Hurricane Planning Commission Meeting Agenda

October 23, 2025
6:00 PM

Agenda Date:	10/23/2025 - Planning Commission
Application Number:	AFP25-11
Type of Application:	Amended Final Plat
Action Type:	Administrative
Applicant:	Teresa Peters
Agent:	Cody Arnoldson
Request:	Approval of an Amended Final Plat.
Location:	3723 W 2800 S
Zoning:	Single Family Residential R1-10
General Plan Map:	Single Family
Recommendation:	Approve subject to staff and JUC comments.
Report Prepared by:	Fred Resch III

Agenda Date:	10/23/2025 - Planning Commission
Application Number:	PSP25-21
Type of Application:	Preliminary Site Plan
Action Type:	Administrative
Applicant:	The Hollows LLC
Agent:	Logan Blake
Request:	Preliminary Site Plan Approval
Location:	2950 S Sand Hollow Road
Zoning:	R1-8 (PDO) (designated Neighborhood Commercial)
General Plan Map:	Planned Community
Recommendation:	Approve subject to staff and JUC comments.
Report Prepared by:	Fred Resch III

PROJECT NAME:
**DESERT SANDS
COMMERCIAL (AREA D)**
4640 WEST DIXIE SPRINGS DR., HURRICANE, UTAH
SHEET NAME:
PRELIMINARY SITE PLAN

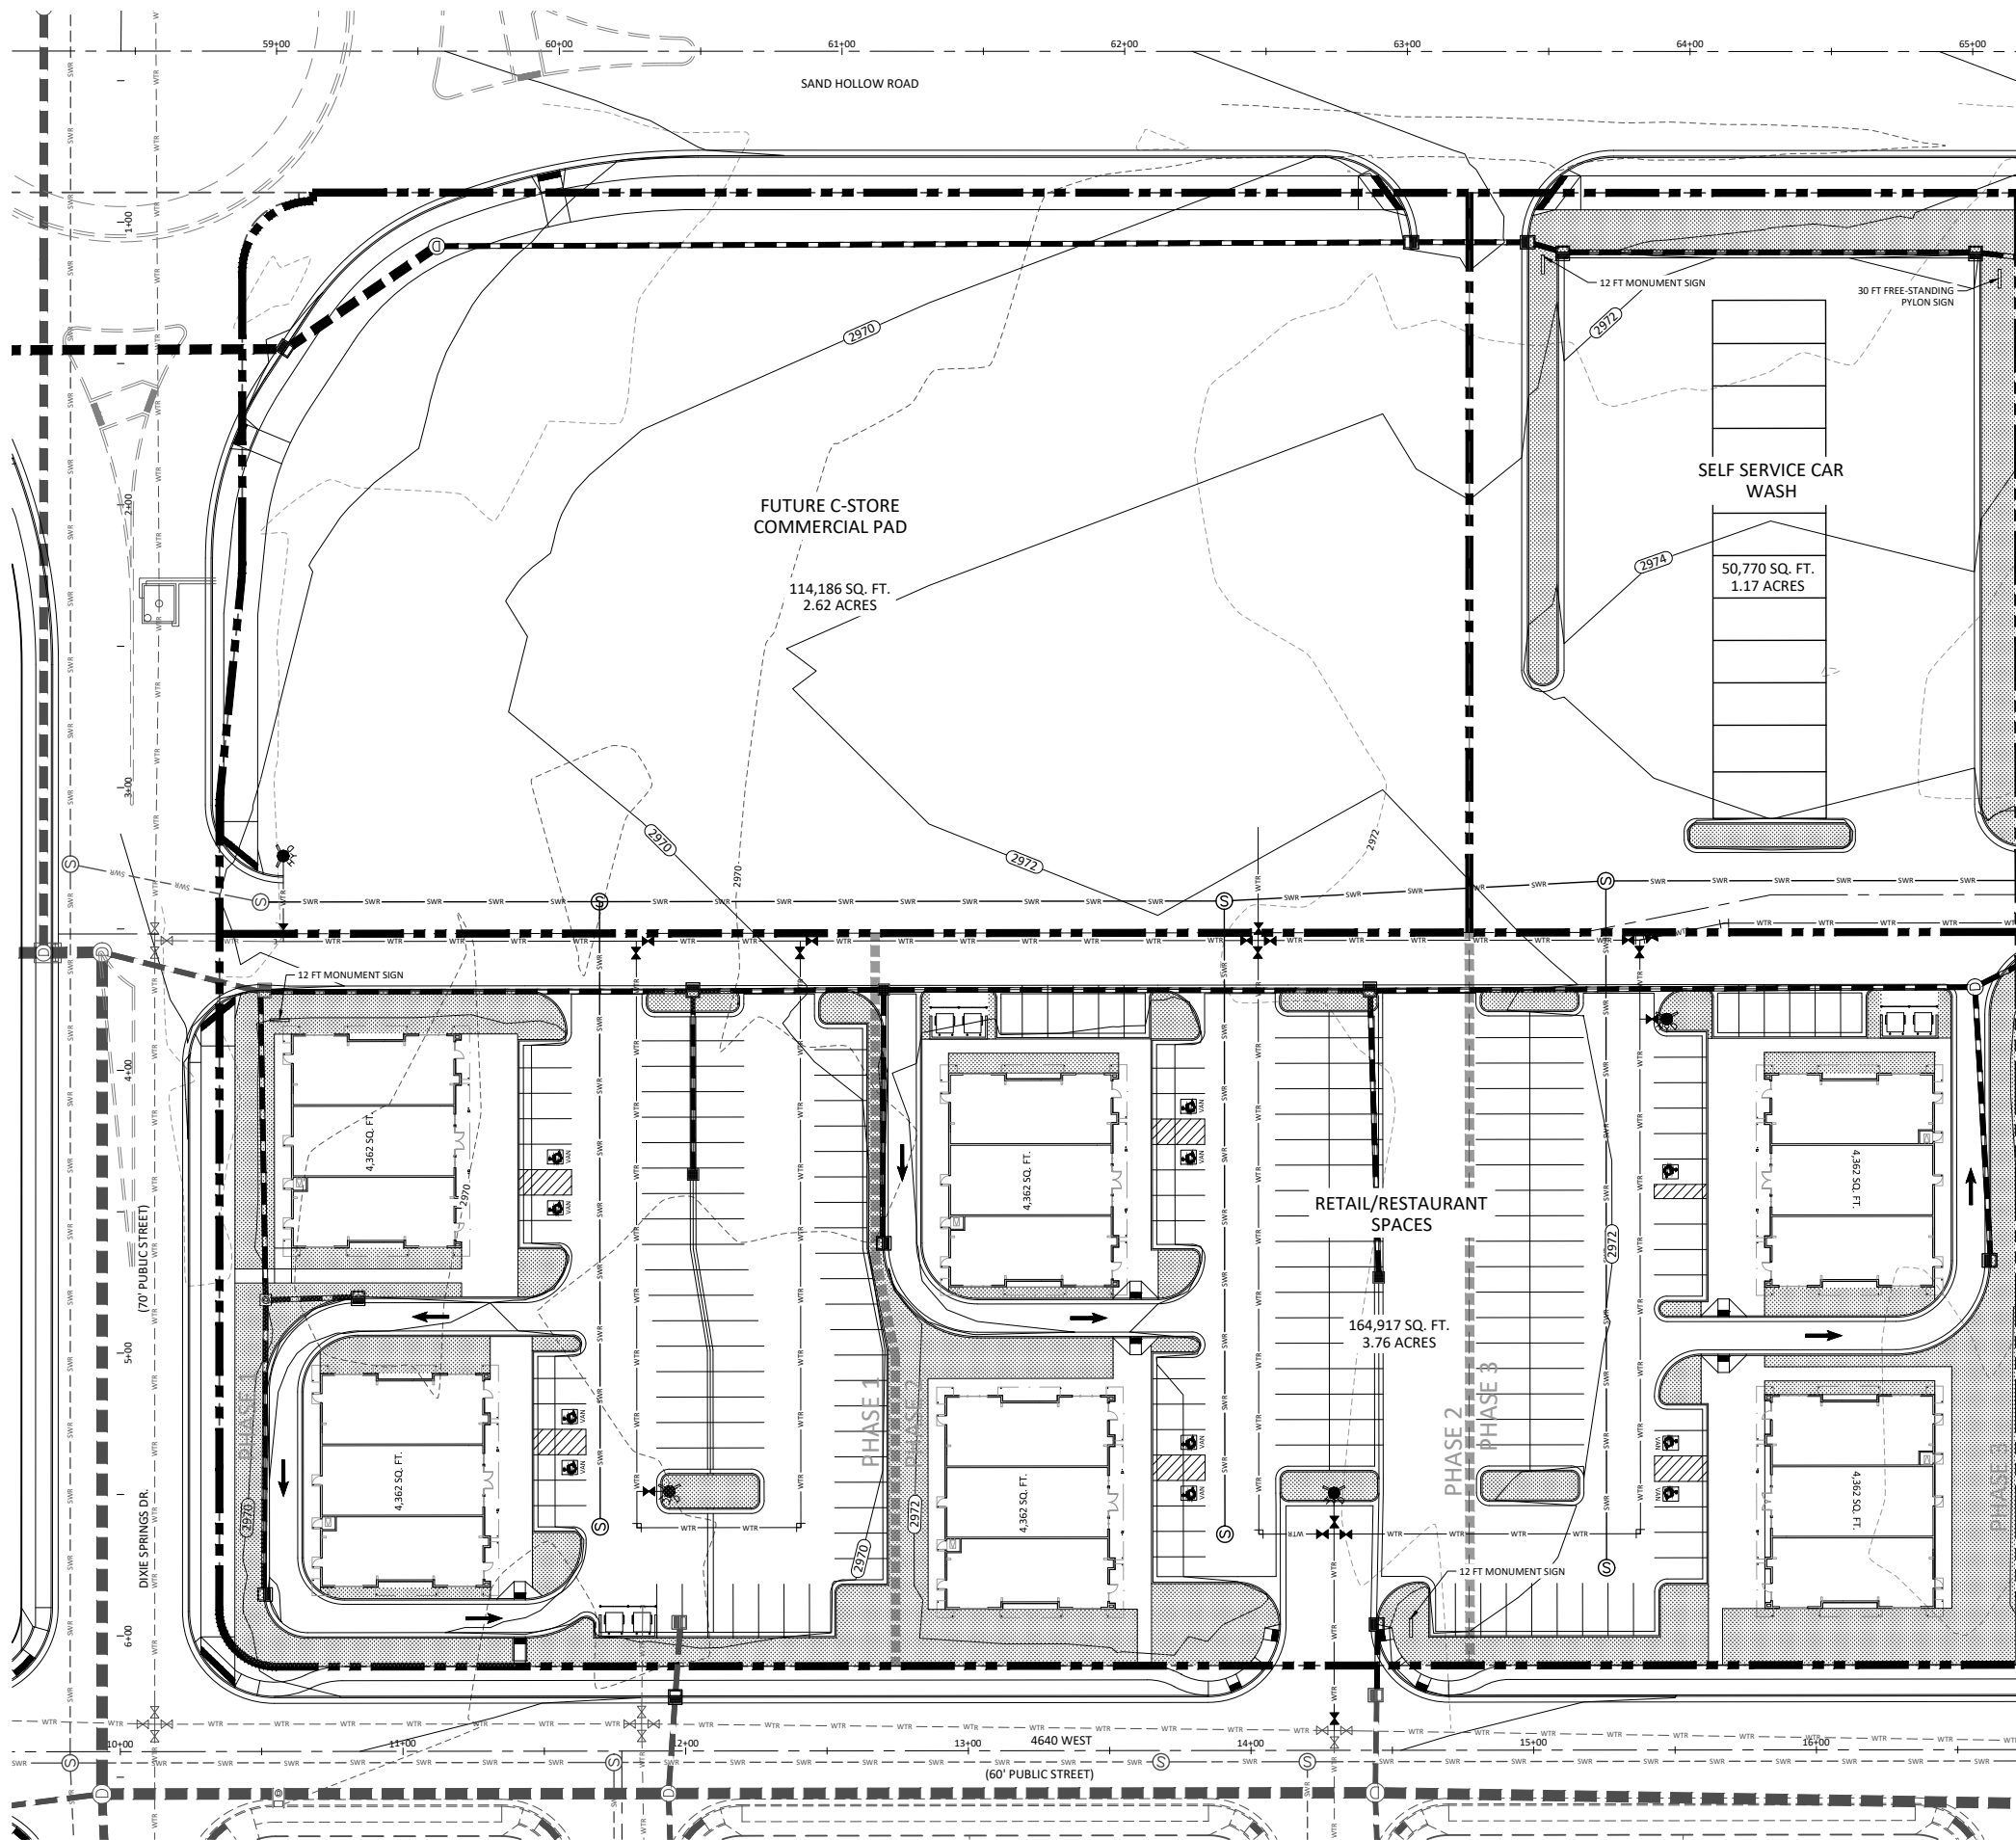
1. **Public Works:** No comment.
2. **Fire:** Approved.
3. **Sewer:** No comment.
4. **Water:** Water line needs to be ductile iron pipe. Water line looping required.

5. **Power:** Dixie Power area. Looks good.
6. **Streets:** No comment.
7. **Gas:** Okay.
8. **Infowest:** No comment.
9. **Engineering:** Sand Hollow Road is an existing 90' public street. A road dedication to make it 112' wide has been distributed for owners' signatures. Recording said dedication must be coordinated with this project (HCC 10-39-11(A)(3)). A large diameter drainage alignment is depicted along Sand Hollow Road on Hurricane City's Storm Drain Master Plan. The project's drainage study must provide commentary on this (item 5, pg. 4-1, Hurricane City's Drainage Manual/HCS 3.4.1). Engineering assumes common area will cover most of the shared areas and shared infrastructure, otherwise easements should be arranged (for utilities and cross access) (see HCS 3.8.4 & HCC 10-35-4(B)(8)). What can we do to encourage a pedestrian connection between Sand Hollow Road and 4640 West (it

appears one would fit nicely between this site and the proposed garage condos site) (HCC 10-33-5(H))?

Road connectivity standards encourage block lengths no greater than 800' (HCS 3.2.4.2(f)). The existing block that separates the residential portion of Desert Sands from the planned Sand Hollow Road trail is approximately fourteen hundred feet. The construction plans must detail how traffic will be controlled at the 4640 W access that is aligned with 2840 South (see HCC 10-7-10(D)(2)(a)(4)). Another vehicle access from 4640 West is encouraged (near the northwest corner of the site, see HCS 3.2.3.8). Landscaping in the street has counted toward 10' landscape strips before (HCC 10-32-6(B)). It appears allowing the drive through closer to the road would make the internal and street layouts better. Engineering needs proposed cross sections for Dixie Springs Drive. Traffic control for Dixie Springs Drive between Sand Hollow Road and 4640 West must be more apparent in the construction plans. What is the proposed pavement width, lane configurations, and such? It appears there are proposed median islands. Engineering provided a suggested layout that should net less concrete and pavement. A typical major collector with a trail is 77' wide.

2. **Parking Requirement:** The applicant is proposing 26,172 square feet of building space and 201 parking stalls, which equates to approximately one stall per 130 square feet of floor area. The exact parking requirement will depend on the specific uses within the buildings; however, with restaurants requiring one space per 100 square feet and retail or office uses requiring one space per 250 square feet, the proposed parking supply will most likely be sufficient. The car wash use requires one space per employee so a "self-service" car wash would require no additional parking stalls.

3. **Landscape:** Hurricane City Code (HCC) requires that a landscape buffer of 10' wide shall front each right-of-way, park strip area does count towards the required buffer. A complete landscape plan will be required with the final site plan in order to verify the requirements of the code section cited below; the necessary space for landscaping appears to be depicted on the preliminary site plan.

4. As stated in Engineering comments above (JUC #9), Planning staff would agree another connection to 4640 W at 2820 S would be better for circulation and an additional pedestrian access from 4640 W to Sand Hollow Road would be preferable.

6. The “Future C-store commercial pad” area will need its own preliminary site plan application when plans are ready for that area.
 7. **No Vesting Rights:** It should be noted that pursuant to Hurricane City Code section 10-7-10 (D)(2)(b): *A preliminary site plan is not intended to permit actual development of property pursuant to such a plan but shall be prepared merely to represent how the property could be developed. Submittal, review, and approval of an application for a preliminary site plan shall not create any vested rights to development.*

Recommendation: The Planning Commission should review this application based on standards in the Hurricane City Code. Staff recommends approval of the preliminary site plan subject to JUC and staff comments.
